SUBJECT: NuScale Power, LLC Response to NRC Request for Additional Information (eRAI No. 8764) on the NuScale Design Certification Application

NuScale Response to NRC Request for Additional Information eRAI No. 8764 - RAI 15.04.02-1

NRC Question No.: 15.04.02-1

NRC Question No.: 15.04.02-2

**Figure 15.4-8: RCS Pressure for Limiting MCHFR Case
(15.4.2 Uncontrolled Control Rod Assembly Withdrawal at Power)**

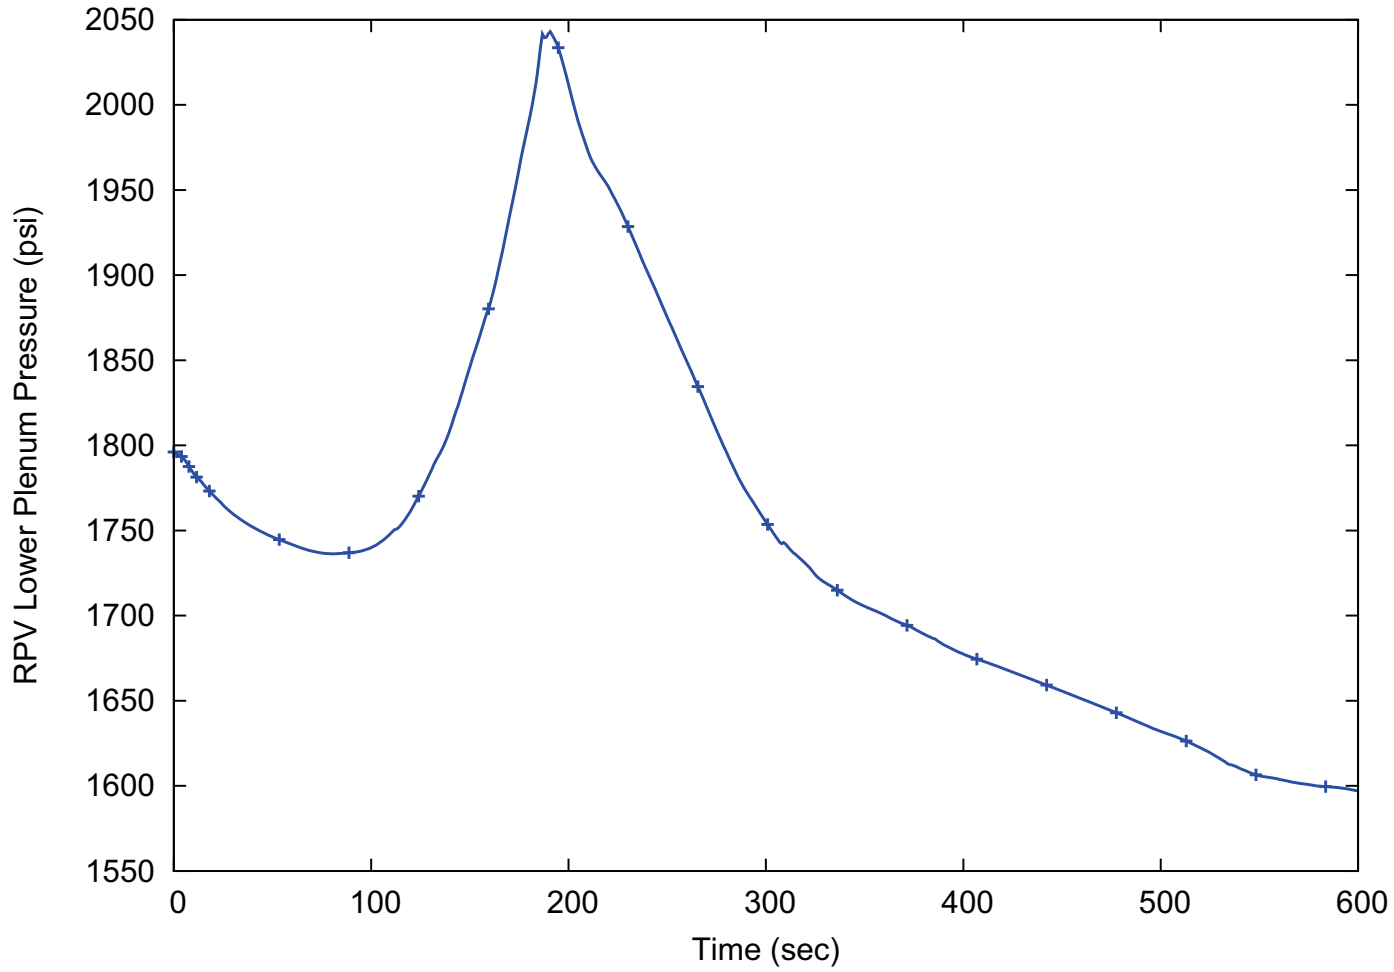
The staff also notes that the RCS pressure verses time given in Figure 15.4-12 (RCS Pressure for Maximum Pressure Case) looks similar to the Figure 15.4-8 (RCS Pressure for Limiting MCHFR Case) except for the offset caused by plotting Figure 5.4-12 against the RPV lower plenum pressure instead of the pressurizer pressure in Figure 5.4-8. Based on the description of the maximum pressure case given in Section 15.4.2.3.3, “Results”, the staff expected a more rapid increase in RCS pressure due to the loss of AC power and corresponding turbine

FSAR Figure 15.4-8 shows pressurizer pressure from the CHFR limiting case. FSAR Figure 15.4-12 incorrectly shows RCS pressure from the CHFR limiting case but was intended to show the limiting pressure case. FSAR Figure 15.4-12 has been updated to show the RCS pressure from the pressure limiting case. The RCS pressure from the pressure limiting case shows a more rapid increase in RCS pressure at the beginning of the transient, as expected.

Figure 15.4-11: **CHFR**Critical Heat Flux Ratio
(15.4.2 Uncontrolled Control Rod Assembly Withdrawal at Power)

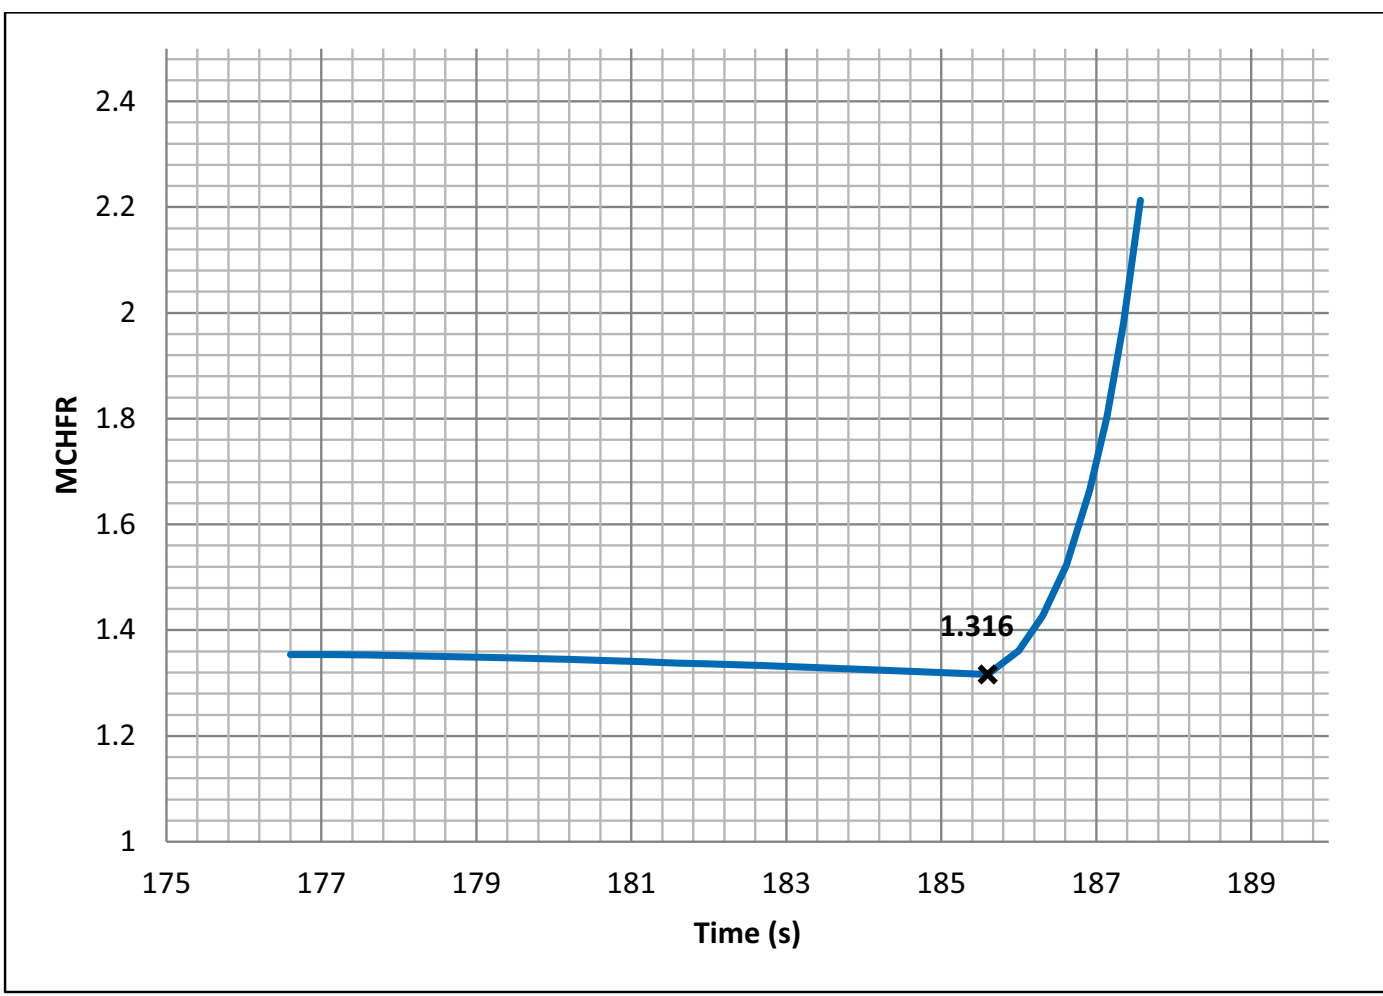
FSAR Tier 2, Figure 15.4-11, “CHFR (15.4.2 Uncontrolled Control Rod Assembly Withdrawal at Power),” shows that the minimum critical heat flux ratio (MCHFR) occurs at about 9 seconds, while the FSAR states that the most limiting MCHFR occurs at the time of the power peak (at about 80 s according to FSAR Tier 2, Table 15.4-3, “Sequence of Events (15.4.2 Uncontrolled Control Rod Assembly Withdrawal at Power),” and Figure 15.4-7, “Reactor Power (15.4.2 Uncontrolled Control Rod Assembly Withdrawal at Power)”). It is unclear to the staff from the docketed information why there is a discrepancy in when the MCHFR occurs and why the timeline of the MCHFR plot does not match the timeline of the power plot in FSAR Tier 2, Figure 15.4-7. Please either ensure the trends are plotted on matching time scales or justify the use of different time scales and update the FSAR as necessary.

NuScale has noted the timescale differences between the results from RELAP and VIPRE1. The subchannel analyses using VIPRE1 focused on the narrower time interval when RELAP predicted MCHFR and not from event initiation. However, the timescales of the VIPRE1 plots provided in the FSAR were not synchronized with the original RELAP plots. FSAR Figure 15.4-11 (CHFR) has been updated to synchronize the event timelines. It was also noted that the incorrect limiting MCHFR case for the uncontrolled control rod assembly (CRA) withdrawal at power event was presented in the FSAR. The MCHFR for the limiting uncontrolled CRA withdrawal at power is 1.316, as reported in FSAR Section 15.4.2.5. However, the event occurs at 75% power, not 102% power. FSAR Section 15.4.2 and associated tables and figures have been updated to present the correct limiting MCHFR event.

**Figure 15.4-12: RCS Pressure for Maximum Pressure Case
(15.4.2 Uncontrolled Control Rod Assembly Withdrawal at Power)**

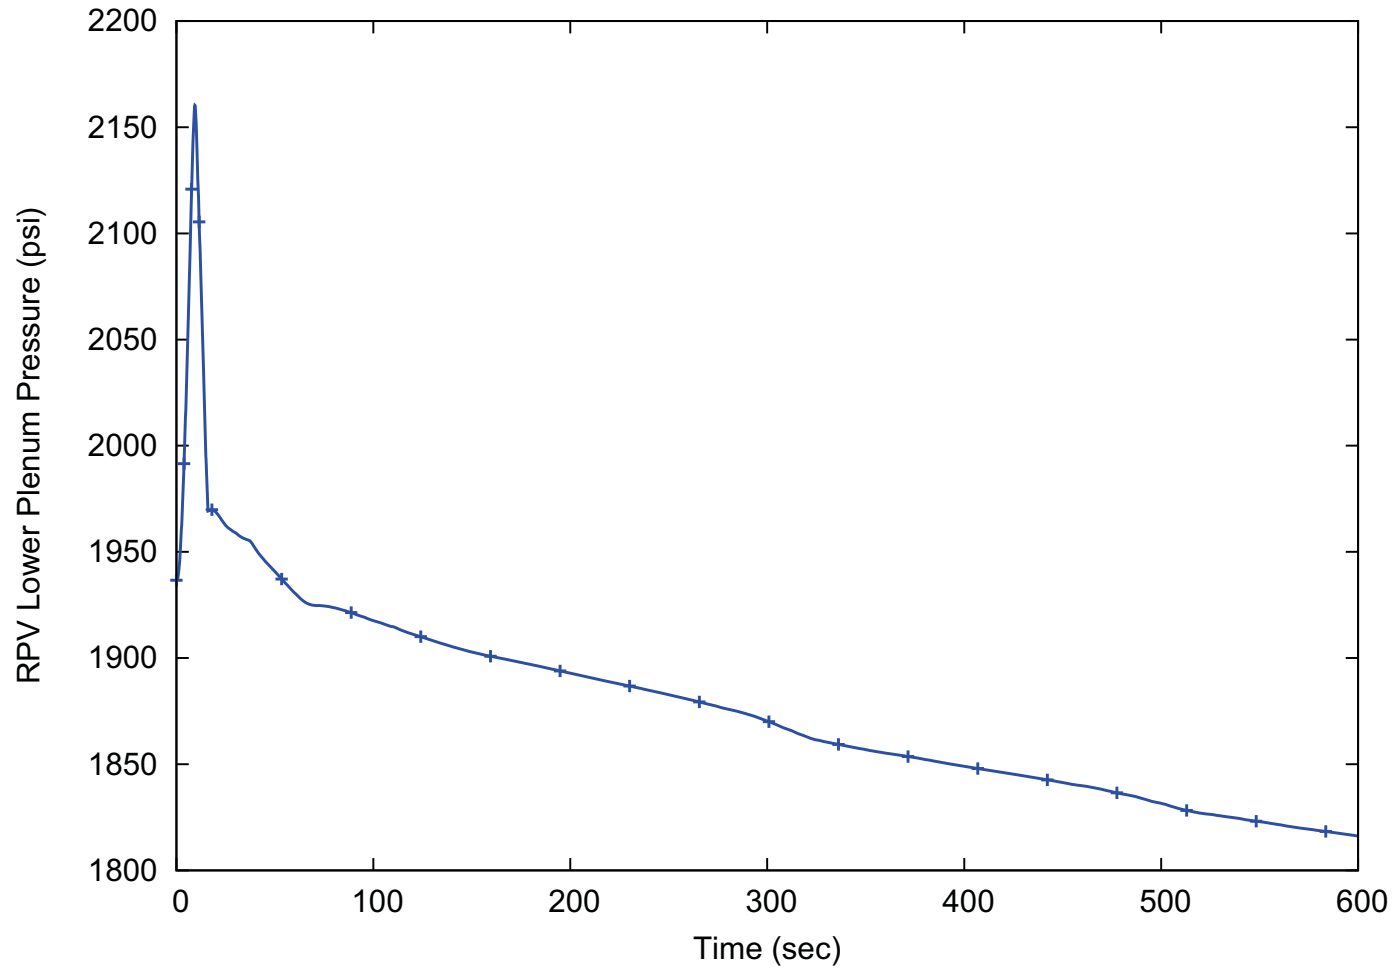
trip at the beginning of the transient. Explain why the RCS pressure for the MCFH and maximum RCS pressure cases have similar pressure versus time responses and include a sequence of event table for the maximum pressure case.

The maximum RCS pressure case is an uncontrolled CRA withdrawal at power with a loss of normal AC power at transient initiation. The pressure for the maximum pressure case is demonstrated in Figure 15.4-12. The loss of AC power at the beginning of the transient trips the turbine and stops feedwater, reducing the heat removal by the secondary side. Simultaneously, the reactivity insertion causes a rapid rise in power. The reactor trips on high power rate, reaching the high pressurizer pressure setpoint almost simultaneously. The pressure continues to rise after the reactor trip, and peaks at the time a reactor safety valve (RSV) opens. Following the RSV opening and reactor trip, the RCS temperature and pressure steadily decrease. The maximum RCS pressure stays below the RPV design limit.

**Figure 15.4-12: RCS Pressure for Maximum Pressure Case
(15.4.2 Uncontrolled Control Rod Assembly Withdrawal at Power)**

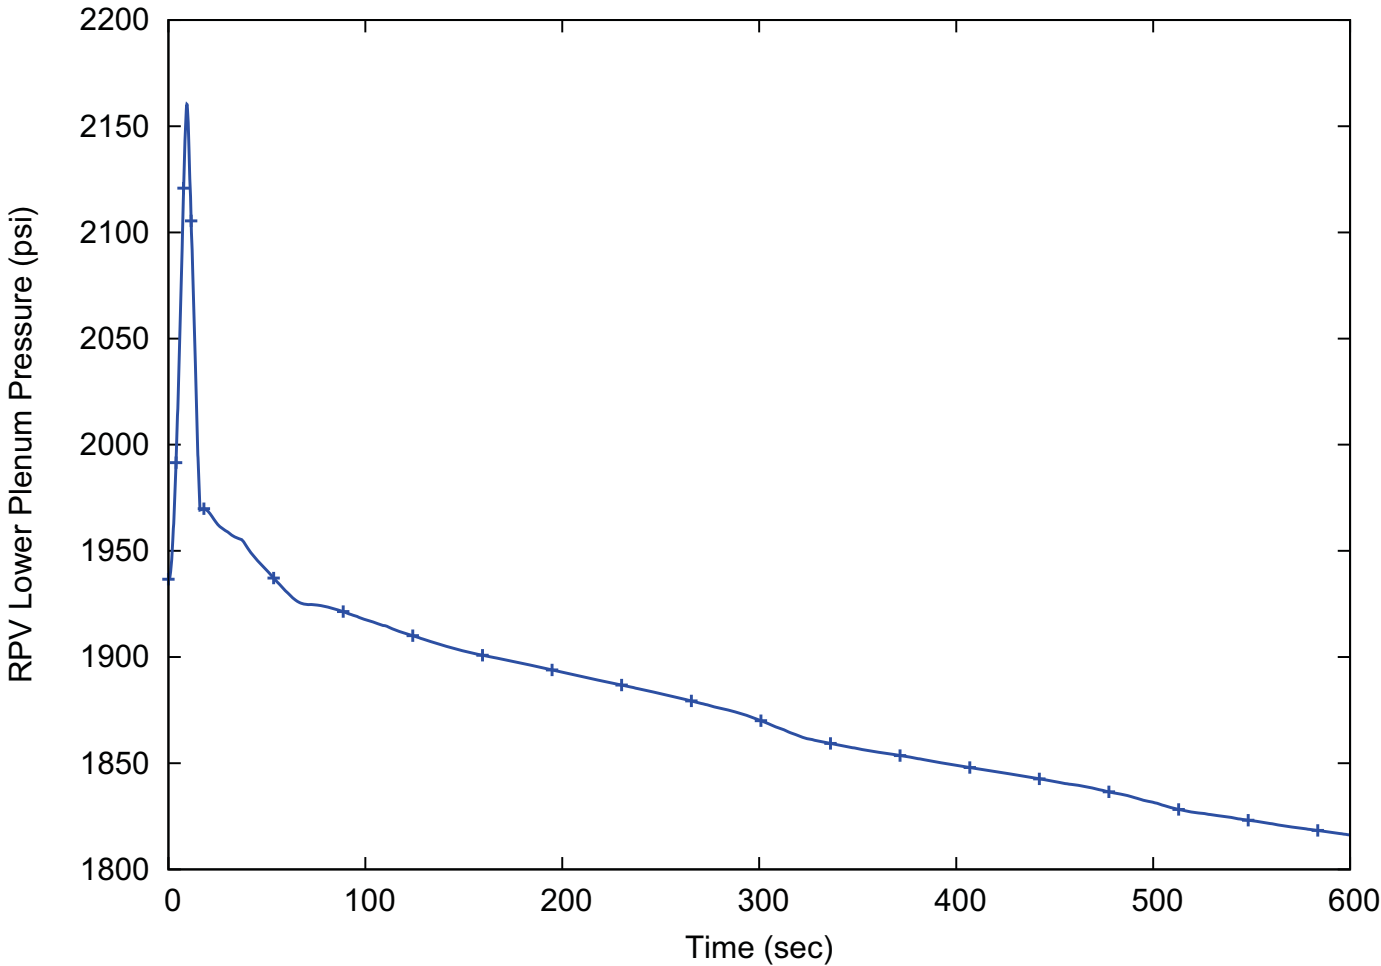
FSAR Tier 2, Figure 15.4-12, “RCS Pressure for Maximum Pressure Case (15.4.2 Uncontrolled Control Rod Assembly Withdrawal at Power),” shows a peak RCS pressure of about 2040 psia, whereas FSAR Tier 2, Section 15.4.2, states that the limiting peak RCS pressure for this event is 2160 psia. Because these pressures are not consistent, the NRC staff is unable to ascertain the limiting RCS pressure for the event. To enable the NRC staff to compare the results of the transient against acceptance criteria and thereby provide reasonable assurance that the relevant GDC is met, please clarify what the correct peak RCS pressure is, and update the FSAR to correct any erroneous information.

As stated in the response to RAI 15.04.02-1, FSAR Figure 15.4-12 has been revised to show the RCS pressure from the RCS pressure limiting case.
